Re: McDonald

1901 Ladera Dr. NW
Traffic Circulation Layout

Engineer's Stamp 11-23-22 (H09-D020)

26 OF 27

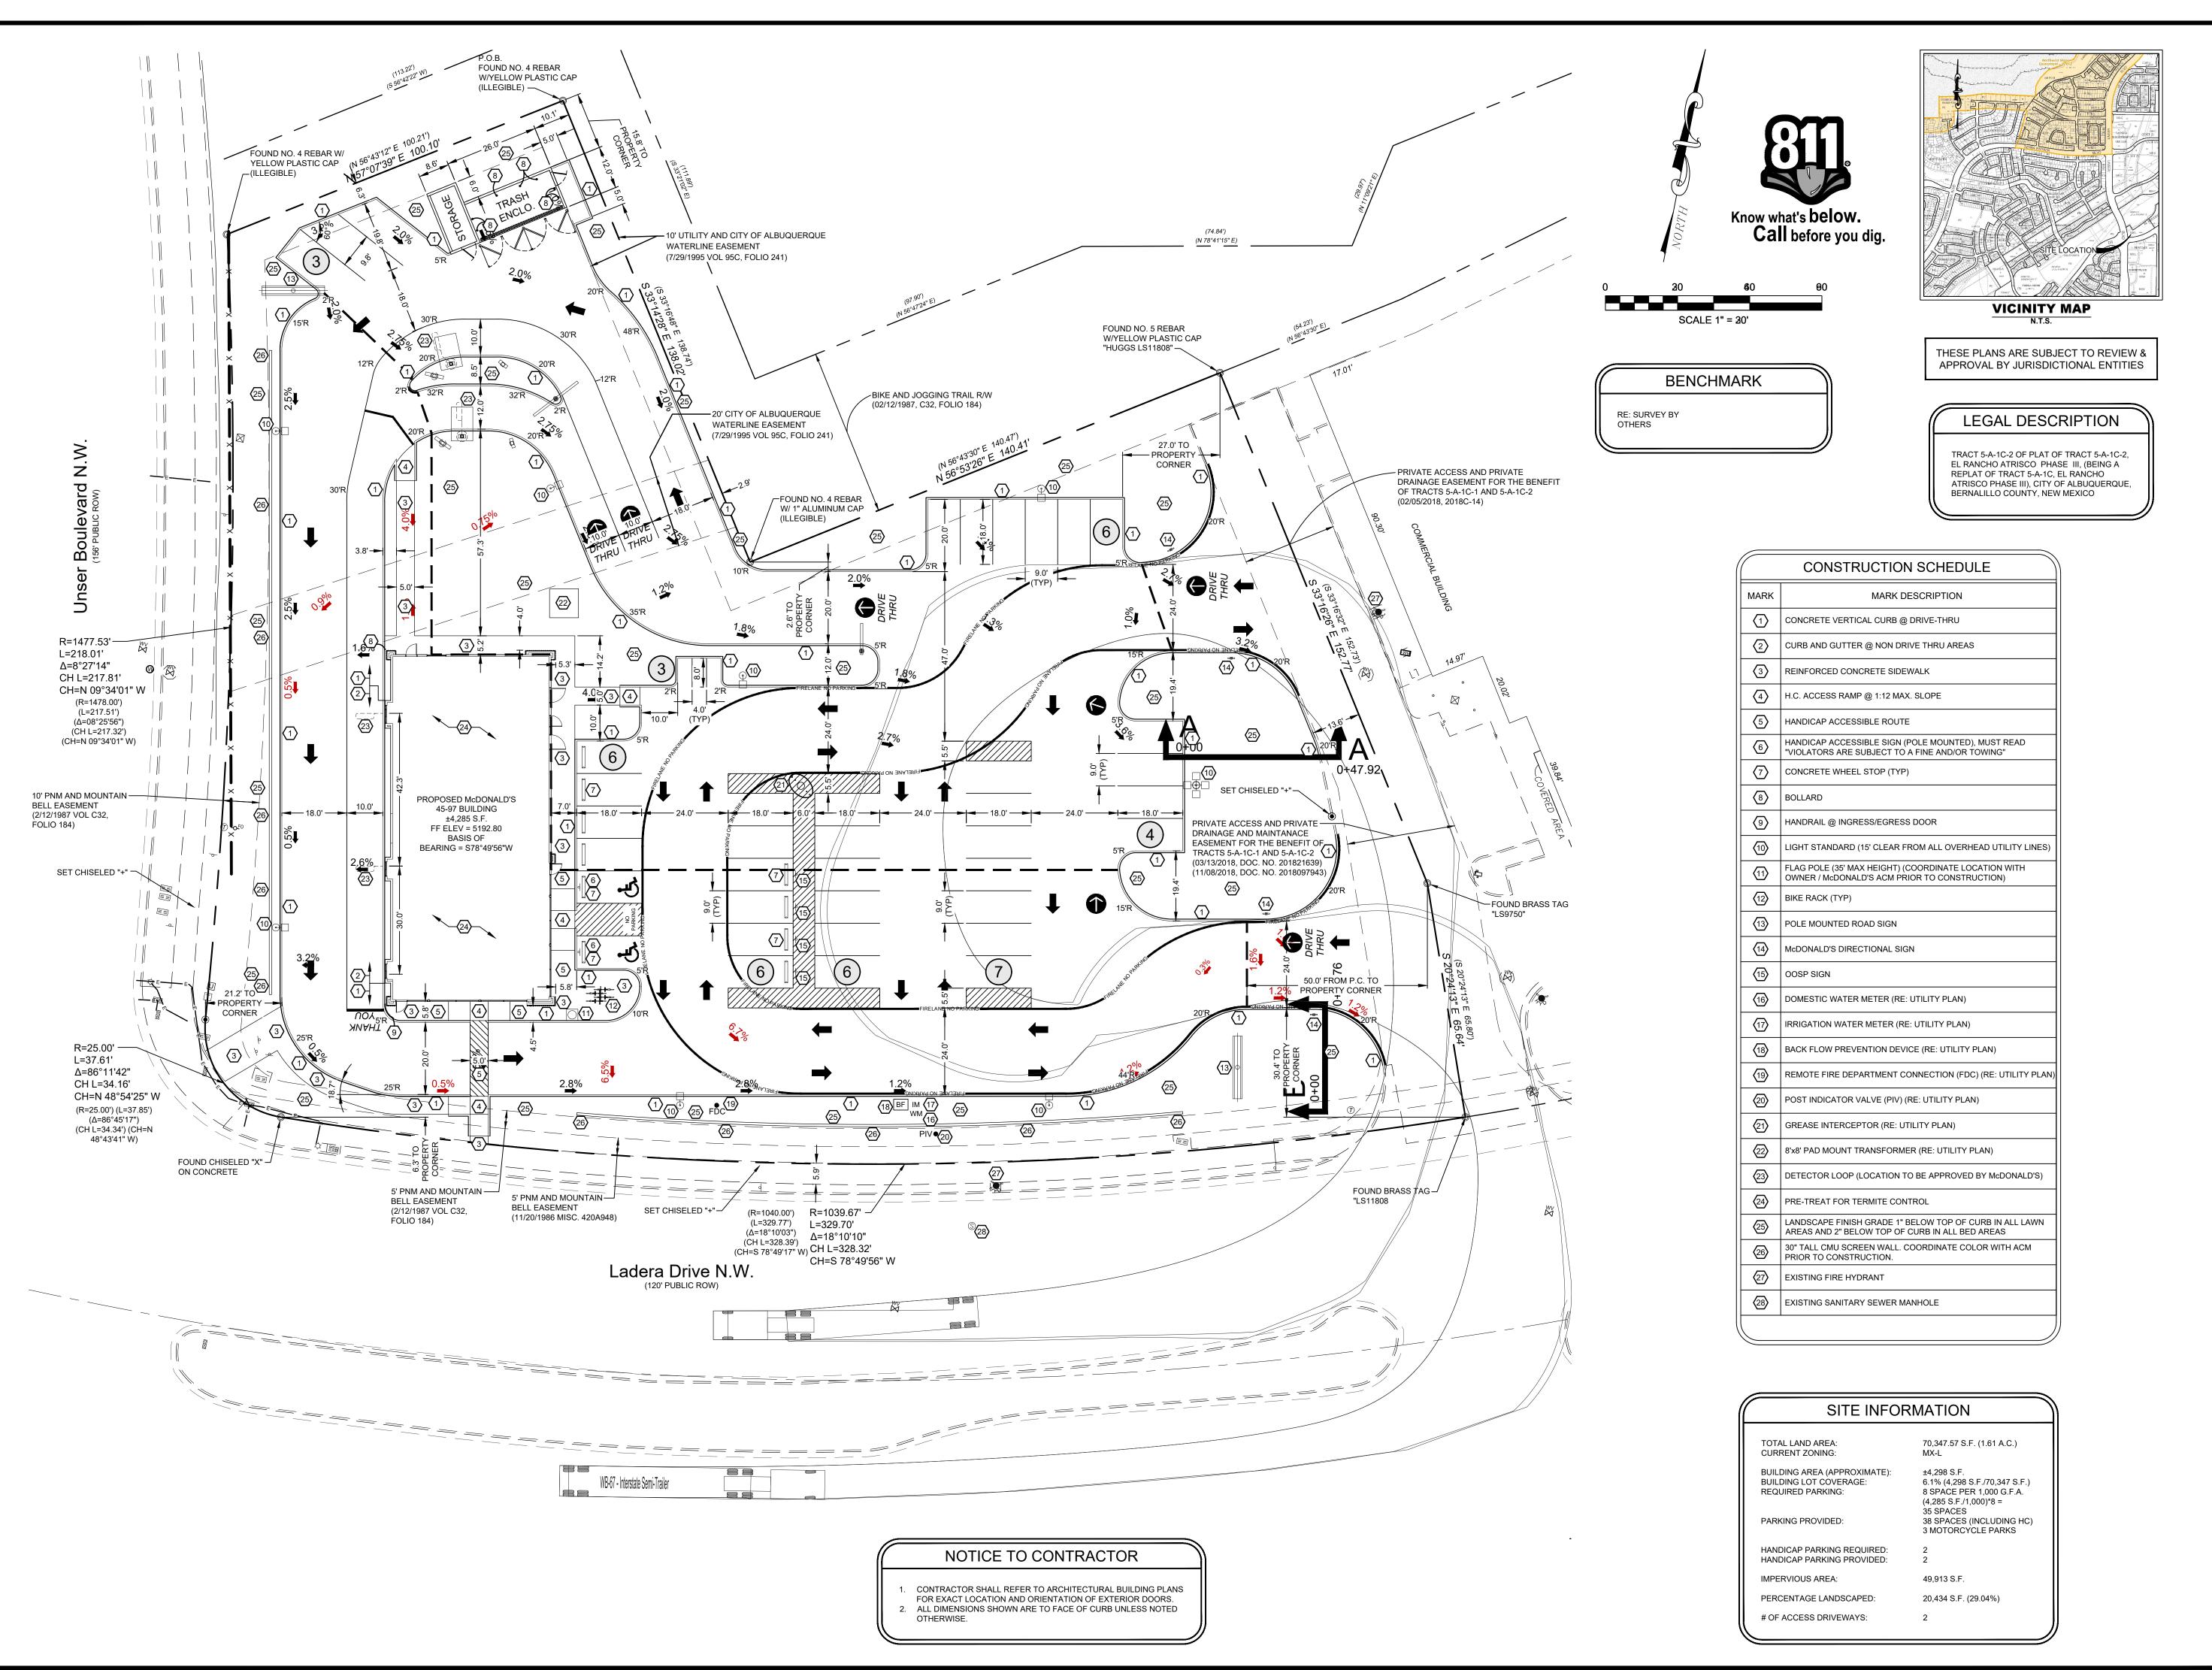
1. Provide approved plat action and/or approved shared access easement with the property on the eastside of the site.

- 2. List the number of Bicycle parking spaces required by the IDO.
- 3. Key note 4: provide design details for the proposed ADA ramps, and add a note "the max. Slope for the landing area in all direction should not exceed 2%".

4. Provide details for all the proposed signs and pavement marking. Please provide face signs details.

- 5. Keynote 3: provide the width for the existing sidewalk.
- 6. Key note 12: provide details for the proposed bike rack.

- 7. Motorcycle parking spaces shall be designated by its own conspicuously posted upright sign, either free-standing or wall mounted per the zoning code.

- 8. The pavement marking "MC" should be shown in the opposite direction for motorcycles entering the parking space.
- 9. All bicycle racks shall be designed according to the following guidelines:

- 11. A 1-foot clear zone around the bicycle parking stall shall be provided.
- 12. Bicycle parking spaces shall be at least 6 feet long and 2 feet wide.

- 13. Show on the site plan the 6' wide ADA pathway from the public sidewalk to the building entrance.
- 14. Refuse vehicle maneuvering shall be contained on-site. The refuse vehicle shall not back into the public right of way. Provide a copy of refuse approval.

- 15. Provide a copy of Fire Marshal approval.
- 16. It is not apparent what type of pavement surface is being proposed. A hard driving surface will be required as part of this proposed project for parking area and drive aisles.

- 17. All one-way drives shall have "One Way" and "Do Not Enter" signage and pavement markings. Please show detail and location of posted signs and striping. Please provide "DO NOT ENTER" sign and pavement marking at the exit of the one way drive aisle at the Southside of the building. And provide a "STOP" sign too.

- 18. The minimum drive through lane width is 12 feet with a 25 foot minimum radius (inside edge) for all turns. (A 15 foot radius can be used with an increase in lane width to 14 feet). Please dimension all lane widths and radii. 10 ft. wide drive lane is not acceptable.

- 19. Show the clear Intersection sight triangle at the driveway access off Ladera Dr. and on the intersection of Ladera Dr. and Unser Blvd. and add the following note to the plan: "Landscaping and signage will not interfere with clear sight requirements. Therefore, signs, walls, trees, and shrubbery between 3 and 8 feet tall (as measured from the gutter pan) will not be acceptable in the clear sight triangle. See attached Intersection sight triangle requirements.

NM 87103 20. Please specify the City Standard Drawing Number when applicable.

- 21. Add a note stating "All broken or cracked sidewalk must be replaced with sidewalk and curb & gutter." A build note must be provided referring to the appropriate City Standard drawing.
- 22. Please provide a letter of response for all comments given.
